SUBJECT: ISSUANCE OF AMENDMENT NO. 40 TO FACILITY OPERATING LICENSE  
NO. NPF-29 - GRAND GULF NUCLEAR STATION, UNIT 1, REGARDING  
CHANGES TO TECHNICAL SPECIFICATIONS REFLECTING ORGANIZATIONAL  
CHANGES (TAC NO. 65883 and 66157)

MISSISSIPPI POWER & LIGHT COMPANY  
SYSTEM ENERGY RESOURCES, INC.  
SOUTH MISSISSIPPI ELECTRIC POWER ASSOCIATION  
DOCKET NO. 50-416  
GRAND GULF NUCLEAR STATION, UNIT 1  
AMENDMENT TO FACILITY OPERATING LICENSE

ATTACHMENT TO LICENSE AMENDMENT NO. 40

SUPPORTING AMENDMENT NO. 40 TO FACILITY OPERATING LICENSE NO. NPF-29

FIGURE 6.2.1-1 OFFSITE ORGANIZATION

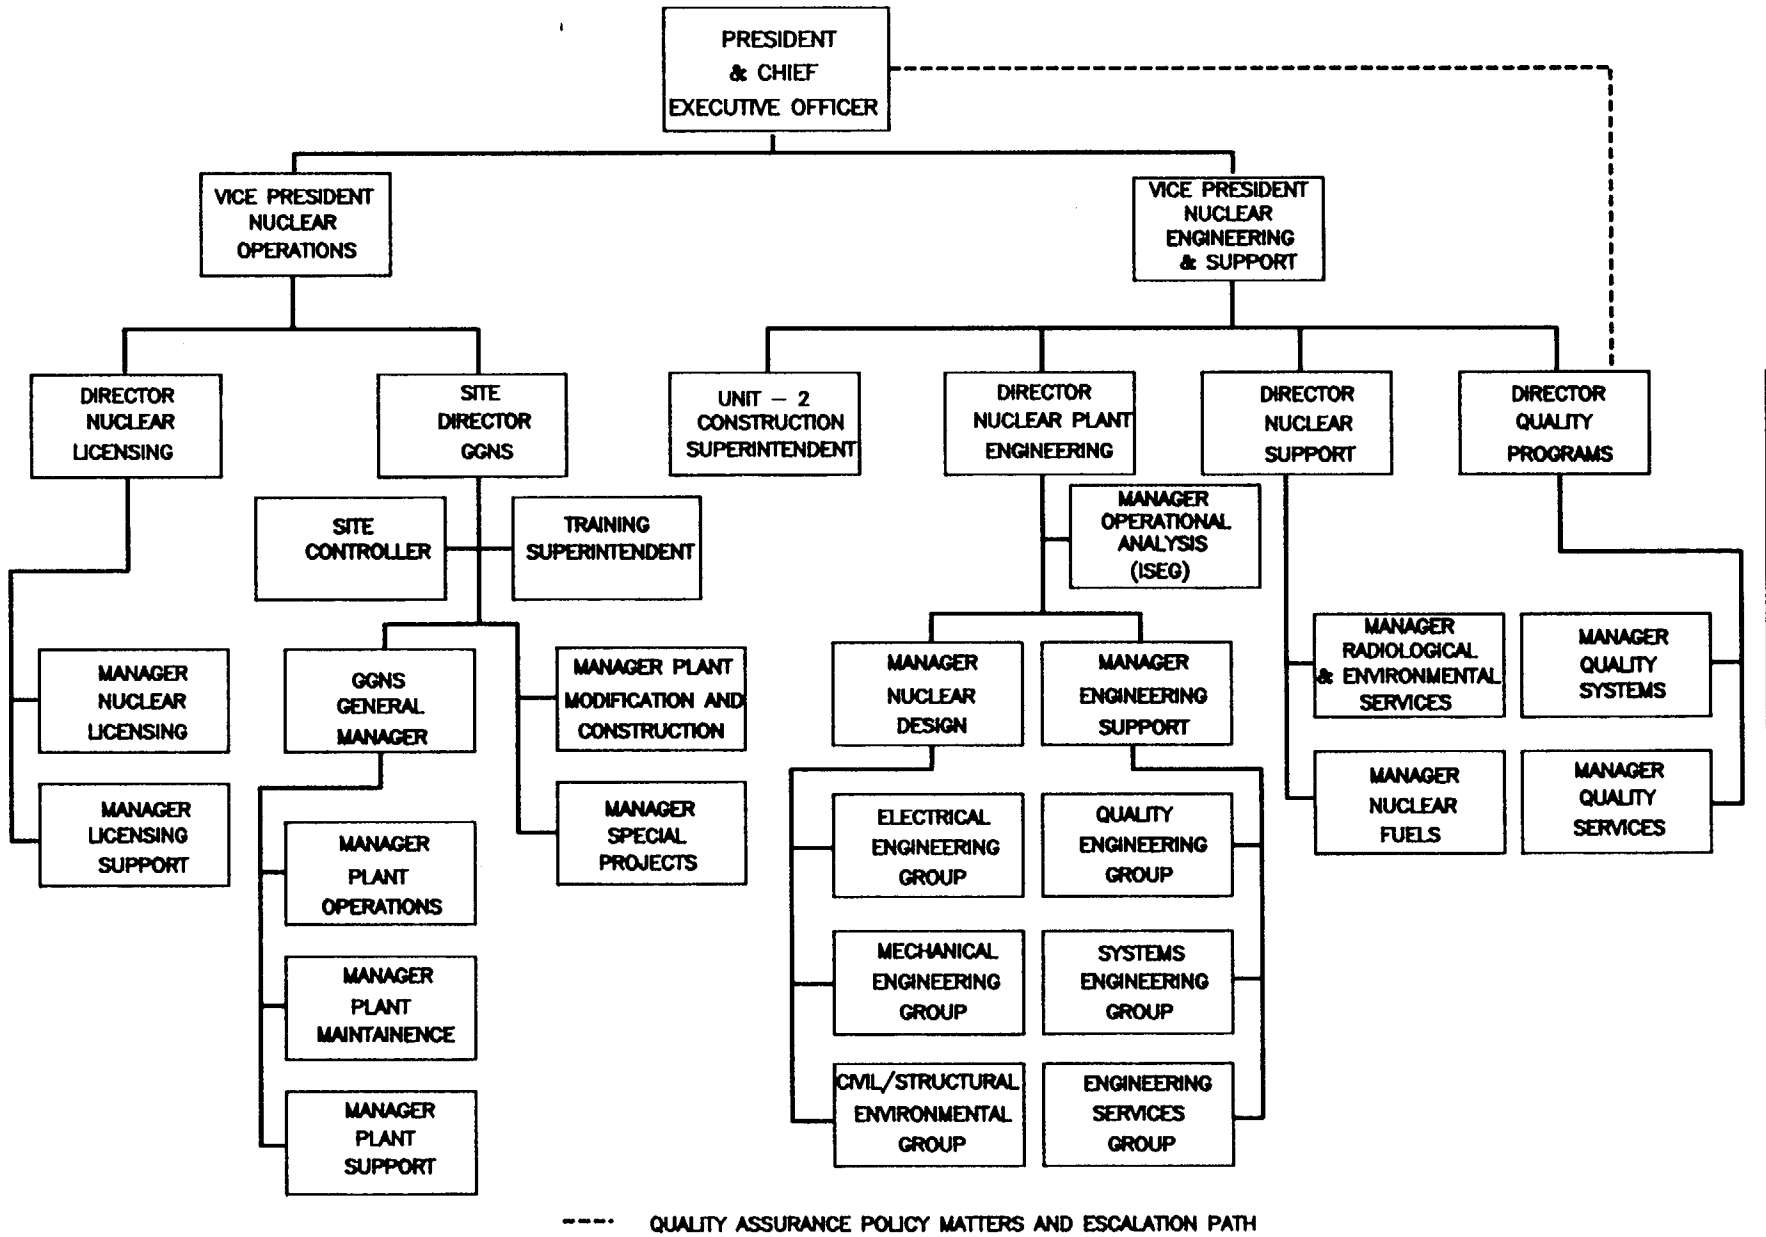
1. Change the present title of Director, Quality Assurance, to Director, Quality Programs, and modify TS Figure 6.2.1-1 and TS Section 6.5.2.2 to reflect this change.

2. Change the present position of Manager, Nuclear Site QA, to Manager, Quality Services, and modify TS Figure 6.2.1-1 and TS Section 6.5.1.2 to reflect this change.
3. Change the present position of Manager, Audits QA, to Manager, Quality Systems, and modify TS Figure 6.2.1-1 to reflect this change.
4. Delete the present position of Manager, Programs QA, and modify TS Figure 6.2.1-1 to reflect this change.

1. Add the position of Manager, Special Projects, reporting directly to the Site Director, GGNS, and modify TS Figure 6.2.1-1 to reflect this change.
2. Delete the position of Manager, GGNS Unit 1 Projects, make the Manager, Plant Modification and Construction, report directly to the Site Director and modify TS Figure 6.2.1.-1 to reflect these changes.

1. Change the organizational unit entitled Operational Analysis Group (ISEG) to the position Manager, Operational Analysis (ISEG) and modify TS Figure 6.2.1-1 and TS Section 6.5.2.2 to reflect these changes.
2. The title of the group leader would be elevated from Principal Engineer to Manager in recognition of the greater importance assigned to this position in the recent reorganization of the Nuclear Plant Engineering organization. The responsibilities of this group would not be changed.

1. Change the present position of Manager, Nuclear Services and Fuels to Manager, Nuclear Fuels and modify TS Figure 6.2.1-1 to reflect this change.

The title change from Director, Quality Assurance, to Director, Quality Programs and the deletion of the word "assurance" from other titles are proposed to emphasize SERI's commitment to total quality, not merely compliance as connotated by "assurance". Total quality includes the in-line control of quality, as well as the independent oversight functions.

The change from the position of Manager, Nuclear Site QA to Manager, Quality Services is proposed to reflect the assignment of in-line functions to this position. The in-line functions under the present Manager, Nuclear Site QA (inspection, non-destructive examination, and non-conformance document reviews), as well as the in-line functional procedure reviews under the present Manager, Programs QA would be under the proposed Manager, Quality Services. Currently, the Manager, Nuclear Site QA, reports directly to the Director, Quality Assurance, and is a voting member of the Plant Safety Review Committee. These relationships would be unchanged.

The change from the position of Manager, Audits QA to Manager, Quality Systems is proposed to reflect the assignment of independent oversight functions to this position. The independent functions of implementation audits under the present Manager, Nuclear Site QA, as well as the independent functions under the present Manager, Audits QA (program audits, vendor audits and evaluations, and procurement related activities) would be under the proposed Manager, Quality Systems. A new functional area of observations/assessments is being developed under this manager to emulate the NRC's Safety System Functional Inspection approach. Additionally, the business support functions of budgeting, computerization, administration, and trending would be transferred from the Manager, Programs QA, to the position of Manager, Quality Systems. Currently, the Manager, Audits QA, reports directly to the Director, Quality Assurance. This relationship would be unchanged.

The proposed change to the quality assurance organization would delete the position of Manager, Programs QA. The functions currently being performed under this position would be transferred to the two manager positions previously described.

The creation of the position of Manager, Special Projects reporting directly to the Site Director and, deletion of the position Manager, GGNS Unit 1 Projects, were proposed to provide a more equal distribution of work and a more effective chain of command for plant projects. The responsibilities of the Manager, GGNS Unit 1 Projects, would be distributed among the Manager, Special Projects; the Site Director; and the Manager, Plant Modification and Construction (PM&C) as follows. The Manager, PM&C, would have responsibility for modification costs and schedules; the Site Director would have responsibility for providing direction to the Manager, PM&C; and the Manager, Special Projects, would have responsibility for project management direction and coordination with the Director, Nuclear Plant Engineering, the Manager, PM&C, and the GGNS Unit 1 General Manager.

The change in position of the nuclear fuels group is proposed to reflect the transfer of the responsibility for administrative support services, such as word processing, to a new organizational unit, Support Services in the corporate offices. This new unit will consolidate administrative support services for several areas including nuclear fuels, nuclear licensing, quality programs, and nuclear support. The Support Services group will report to the Manager, Contracts and Support Services and is not included in TS Figure 6.3.1-1 because of the administrative nature of the functions.
